**Charlotte-Mecklenburg Planning, Design, & Development**

**SUBJECT:** Administrative Approval for Petition No. 2019-133 Greg Zanitsch, TBGC, LLC

**CONCEPTUAL  
 REZONING SITE  
 PLAN**

Petition # 2019-133

Z1.02  
wall  
treatment

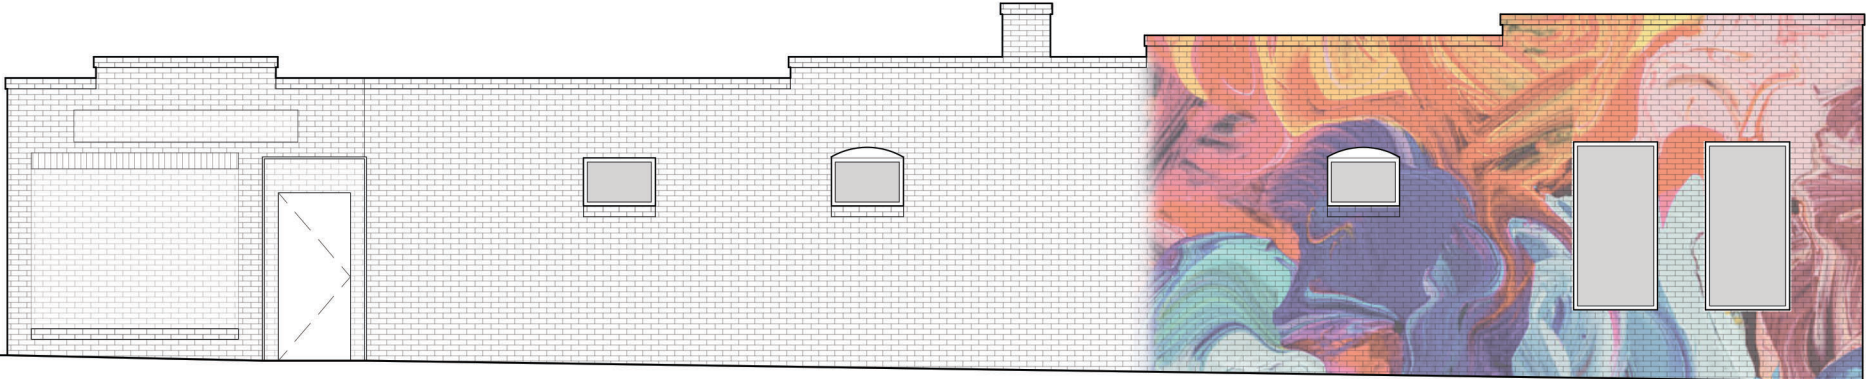
- Revised building elevation for existing building along the public street frontage.
